# Access Compliance Report

## Public Rights-of-Way

### (Curb Ramps)

Intersection ID: 43154	Main Street: KILDARE_DR	Cross Street: SHANNONHOUSE_DR	Location: SW
ADA ID: D3ADCDC3A61E	Ramp Type: Directional1	Initial Pass/Fail: Fail	Overall Compliance: No
Severity Score: 25			
Codes/Mitigation Info/Possible Solution		Field Measurements/Component Compliance

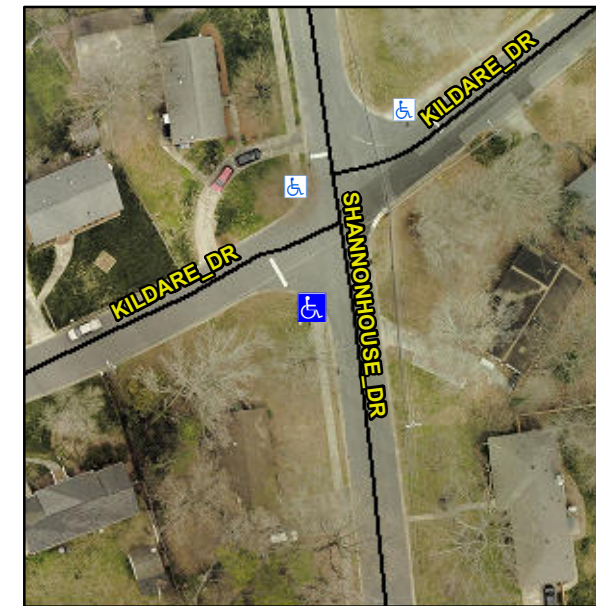
Compliance	Description	Data	Compliance	Description	Data
N/A	Ramp Length (in)	147.5	N/A	Grade Break?	N/A
Yes	Ramp Width (in)	61.5	N/A	Grade Break Slope (%)	0.0
No	Ramp Slope (%)	16.0	N/A	Grade Break XSlope (%)	0.0
Yes	Ramp XSlope (%)	1.9			
N/A	Flare Type LT	N/A	N/A	Flare Type RT	N/A
N/A	Flare Slope LT (%)	N/A	N/A	Flare Slope RT (%)	0.0
N/A	Flare Traversable LT?	N/A	N/A	Flare Traversable RT?	N/A
N/A	Landing Length (in)	0.0	N/A	DWS Provided?	N/A
N/A	Landing Width (in)	0.0	N/A	DWS Contrast?	N/A
N/A	Landing Slope (%)	0.0	N/A	DWS Length (in)	N/A
N/A	Landing X Slope (%)	0.0	N/A	DWS Full Width?	N/A
N/A	Landing Curb? (Y/N)	N/A	N/A	DWS Offset LT (in)	N/A
N/A	Shared Landing?	N/A	N/A	DWS Offset RT (in)	N/A
N/A	Gutter Ponding?	0.0	N/A	Gutter Slope (%)	N/A
N/A	Gutter Lip Ht (in)	1.0	N/A	Gutter X Slope (%)	N/A
N/A	Painted X Walk1?	No		Road Slope (%)	3.0
	X Walk 1 Direction	To N		Road X Slope (%)	3.8
	X Walk 1 Width (in)	N/A		Clear Space?	N/A

X Walk 1 Slope (%)	3.0	N/A	Clear Space to XWalk (in)	N/A
	X Walk 1 X Slope (%)	3.8	N/A	Storm Grate/Utility Hazard?	N/A
N/A	Ramp inside XWalk1?	N/A		Storm Grate/Utility Type	
N/A	Any Obstructions?	N/A			N/A
	Obstruction Type		Yes	Surface Condition? (G/P)	Good
			N/A	Curb Slope (%)	13.7

**Remove & Replace Entire Ramp.**
